FINAL PHASE I
CONTAMINATION ASSESSMENT REPORT
SITE 36-12: PITS/TRENCHES
(Version 3.2)

January 1988
Contract Number DAAK11-84-D0016
Task Number 1 (Section 36)

**FINAL RESPONSE TO SPECIFIC COMMENTS OF
COLORADO DEPARTMENT OF HEALTH
TASK 1, DRAFT FINAL PHASE I REPORT
SITE 36-12: PITS/TRENCHES**

**FINAL RESPONSE TO SPECIFIC COMMENTS OF
SHELL OIL COMPANY ON
TASK 1, DRAFT FINAL PHASE I REPORT
SITE 36-12: PITS/TRENCHES**

Figure 36-12-5
PHASE I INVESTIGATION
BORING LOCATION MAP
SITE 36-12
SOURCE: ESE, 1987

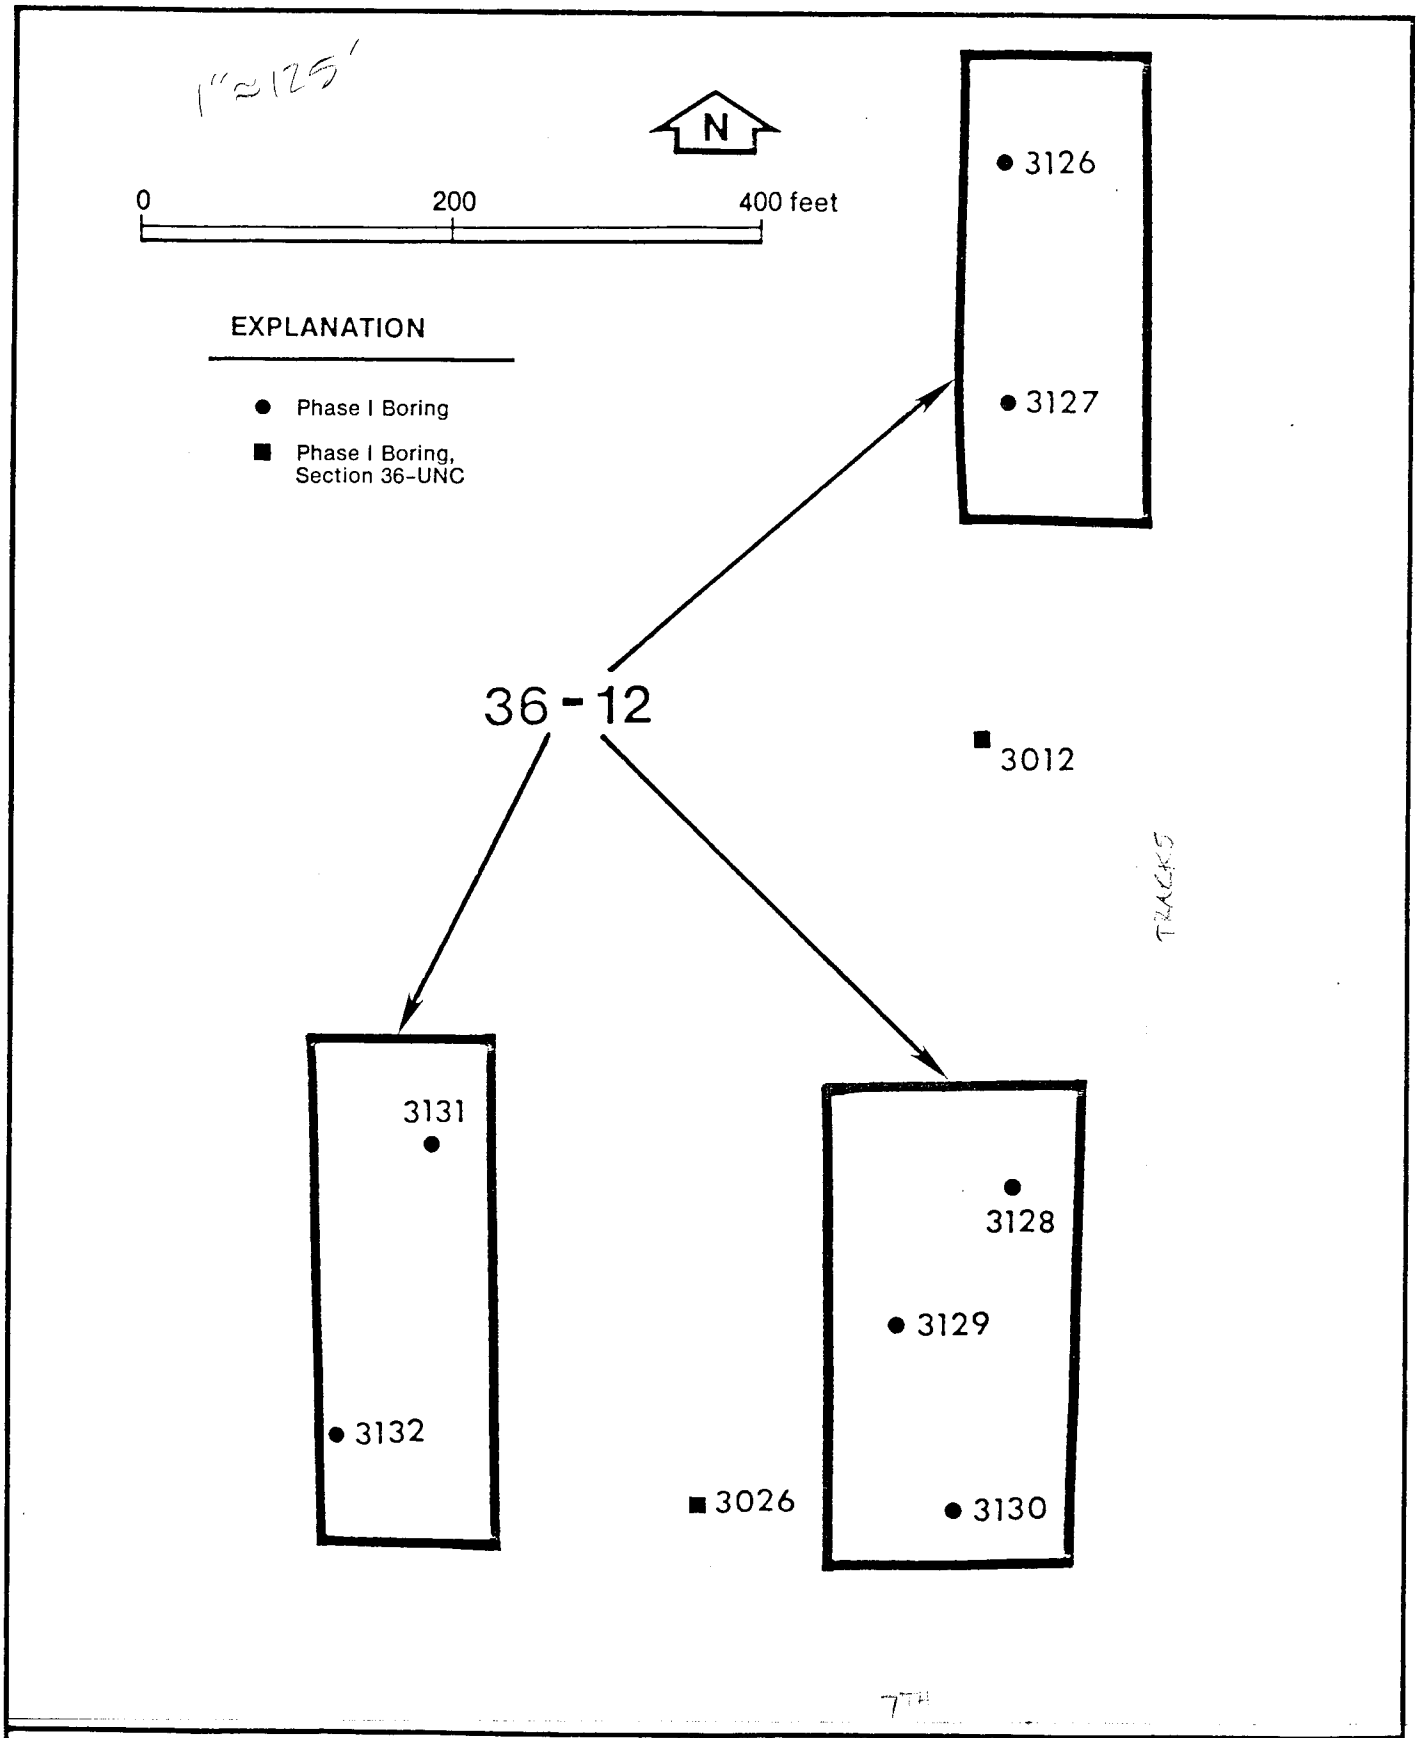
Comment 1:
P. 36-12-2 Boring location for 3010 needs to be corrected.

Response: Boring location for 3010 has been corrected.

Figure 36-12-6
PHASE I INVESTIGATION
CHEMICAL ANALYSIS RESULTS,
SITE 36-12

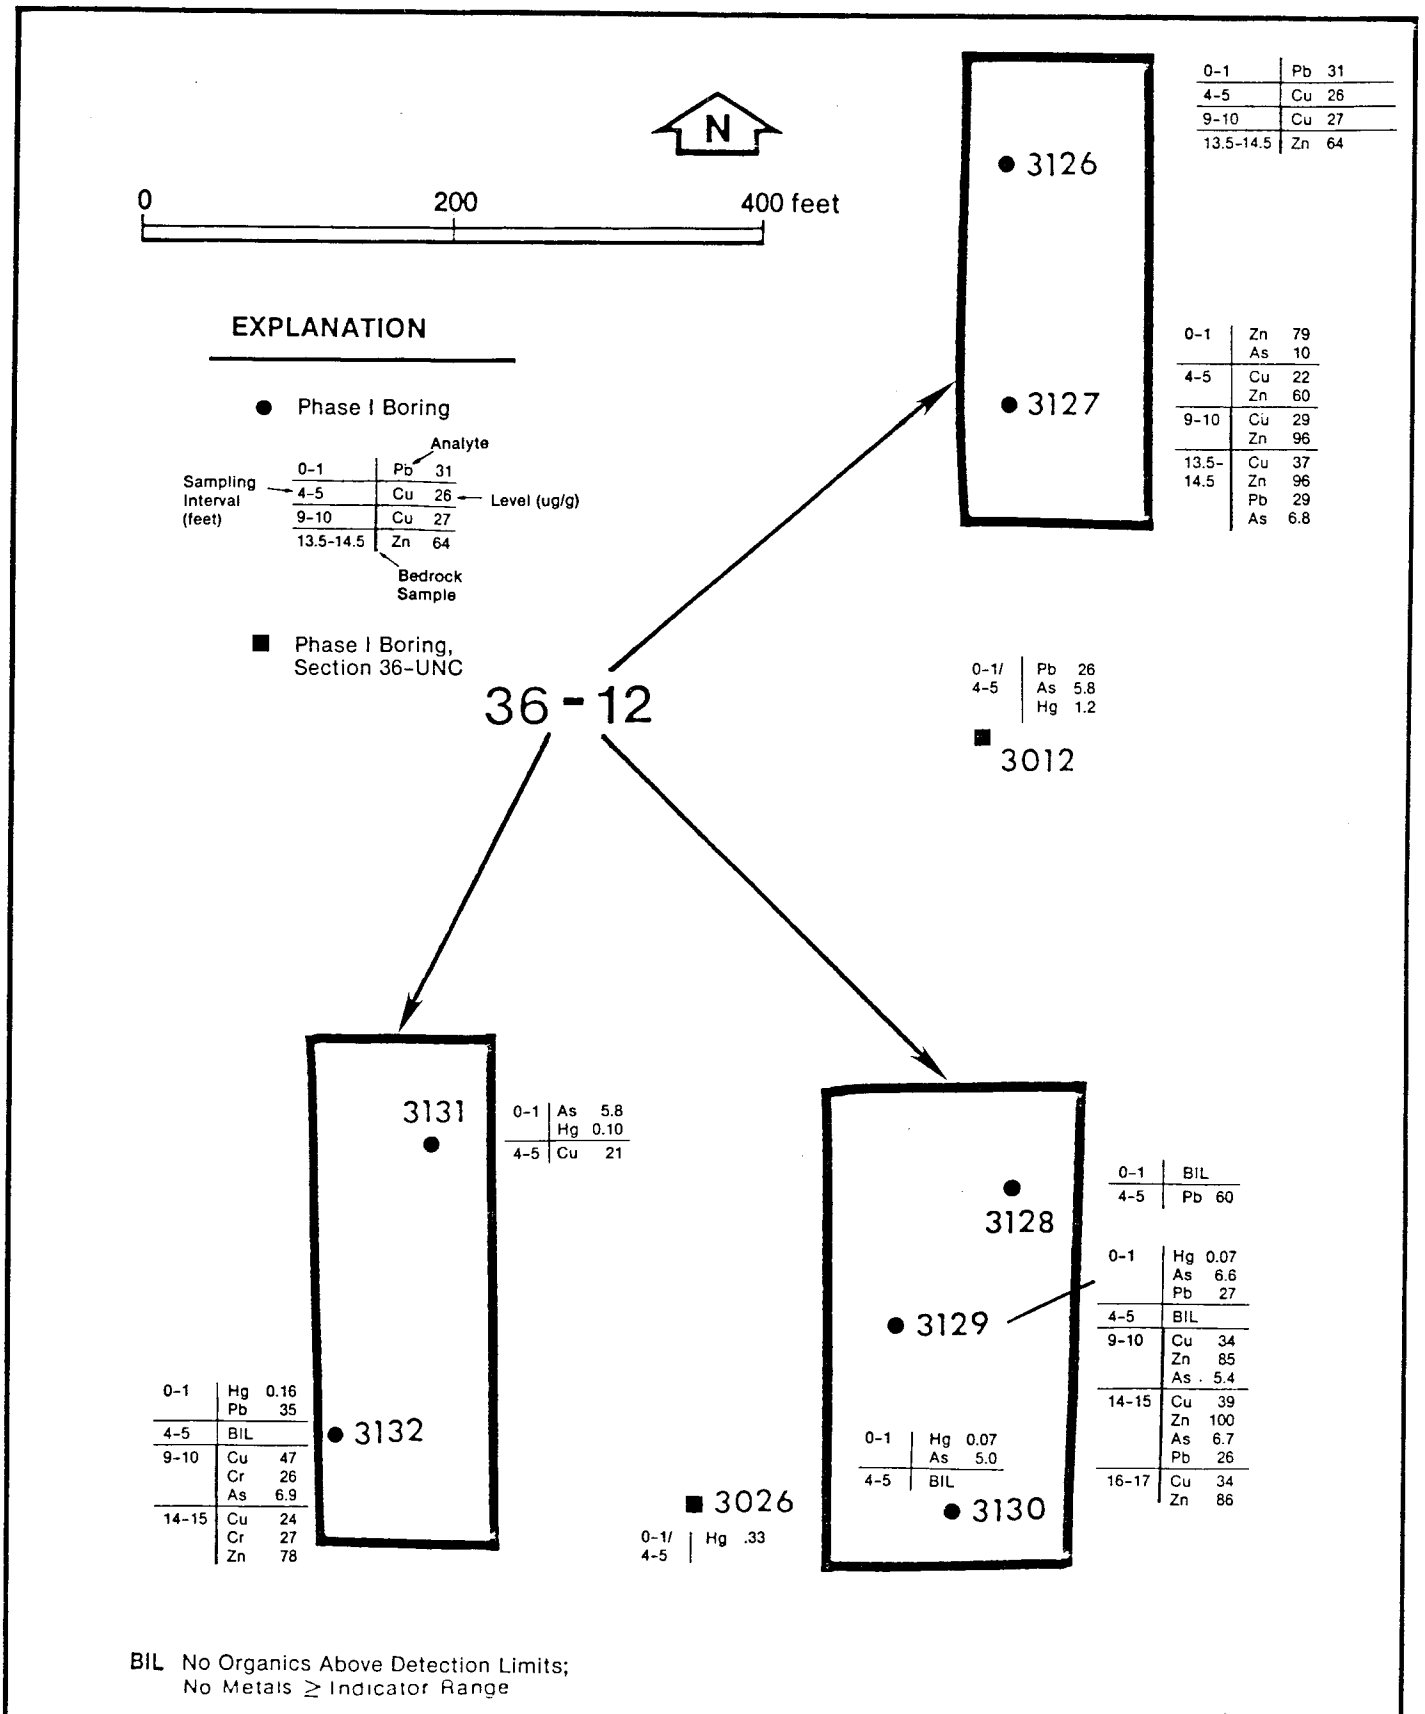
Comment 2:
P. 36-12-12 Boring 3127 had arsenic at 10 ug/g in A interval; Boring 3131 had mercury at 0.1 ug/g in A interval. These need to be indicated.

Response: The figures only showed values above the lower indicator level at that time. These results have been added to the figure.
